### 85.8.4.2 Receiver interference tolerance test at TP3

### 85.8.4.3 Test setup

Figure 85.X interference tolerance test setup

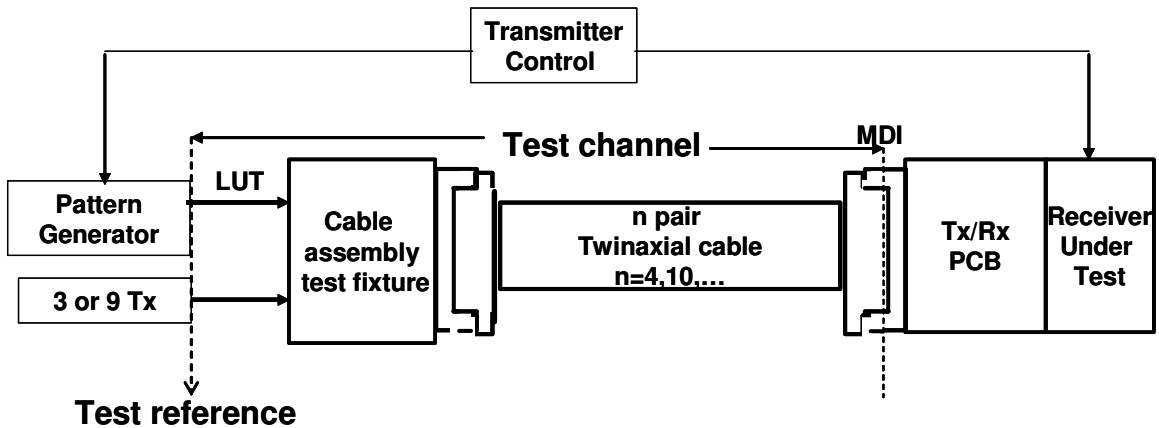
Editors note: [Add Tx under receiver under test with dashed line in receiver under test block and pattern generator connection label]

**Figure 85.XX Test channel**

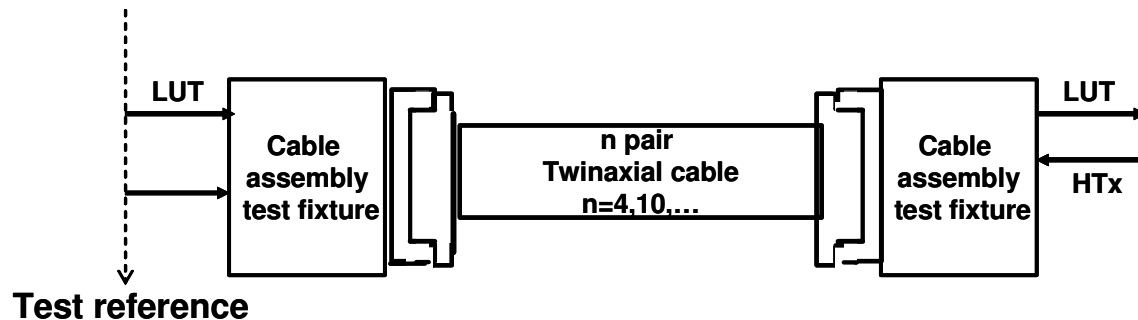
**Editor note: [Make reference plane at cable assembly test fixture test reference]**

The far-end crosstalk disturbers [add to far-end source to figure] consist of 40GBASE-CR4 or 100GBASE-CR10 transmitters. It is recommended that the transition time, equalization setting, and path from the far-end crosstalk
